COMMONWEALTH OF PENNSYLVANIA
DEPARTMENT OF GENERAL SERVICES
HARRISBURG

SOLICITATION # 95015

PA STATE POLICE

Communication Room Specifications

**Ebensburg Station
Communications/Dispatch Room
Drawing**

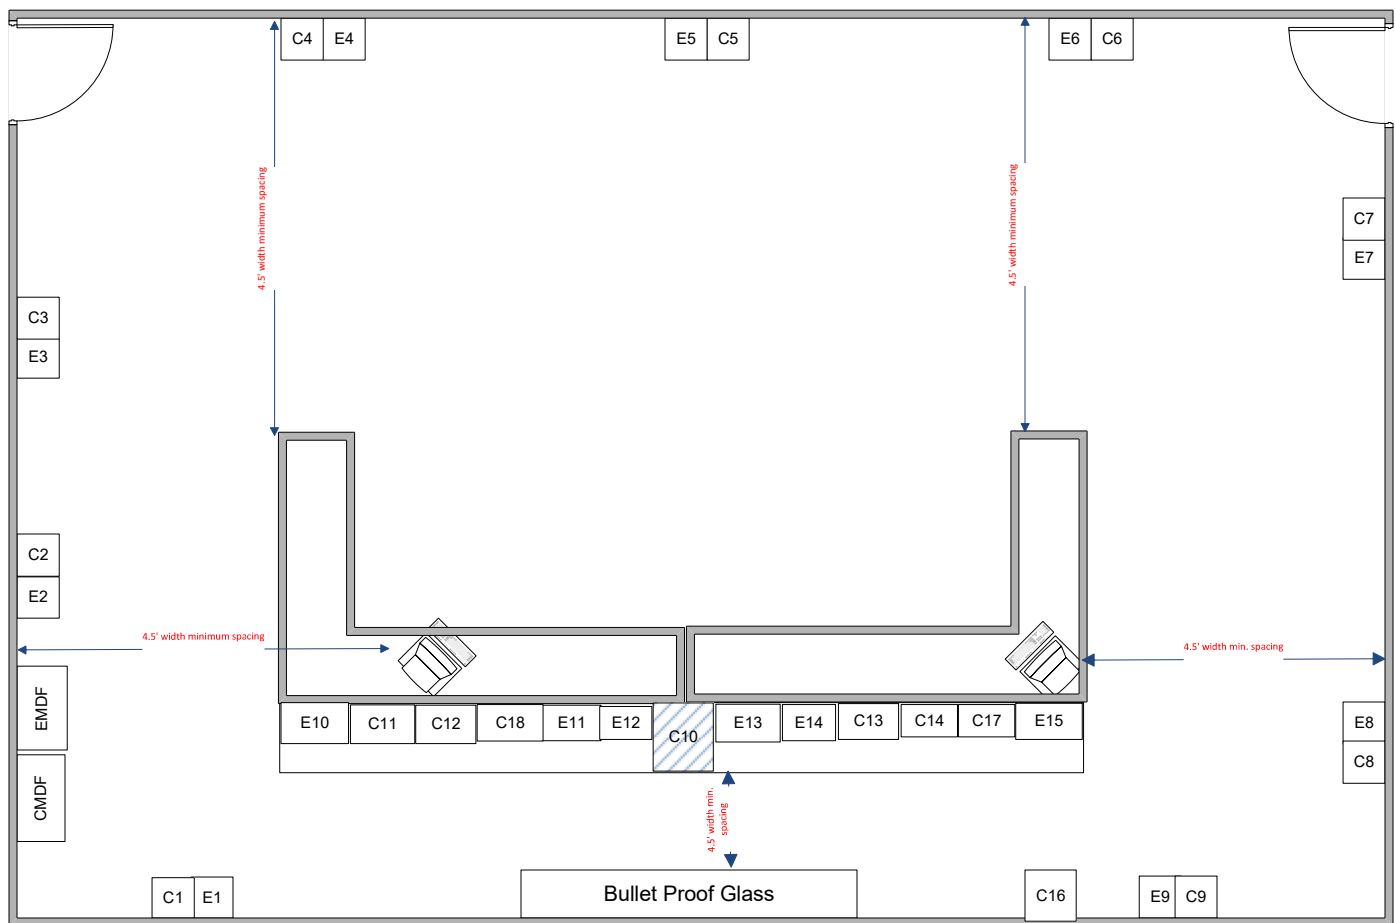
Details for the Communication Room Specifications are added via this addendum. Details are; Ebensburg Station Communications Specifications Date 7/11/19 V.U. and Ebensburg Station Communications/Dispatch Room Drawing 7/11/2019 V.U..

1. EMDF and CMDF panels shall be connected to the telephone/utility room via conduit.
2. Receptacles E1 through E9 shall be dual socket.
3. C1 through C9 shall be 3/4" conduit as described in the BIT specifications, C10 shall be 3" conduit to the CMDF

4. E10 through E18 shall be a quad socket wall style outlet, one 20A circuit breakers per quad powered by the EMDF panel. C12 through C14 will be 6 outlet RJ-45 outlets or as described by BIT.

5. E10 through E15 inclusive and C10 through C14 inclusive shall be inside a 16' long wall, 42" high. Wall will have removable back (side facing towards window) for rewiring access.

6. C16 shall be a thru wall conduit for lobby telephone/intercom.
7. C17 and C18 will be dual RJ45 jacks marked Radio Only and wired to the 110 block in the CMDF.

8. All Communication Room power outlets, lobby exit lights, vestibule lights, and overhead lights in the Communications Room shall be connected to the emergency power provided by the EMDF panel.

9. Spacing should be at a 4.5' minimum applicable to the areas indicated for ADA accommodations and compliance.
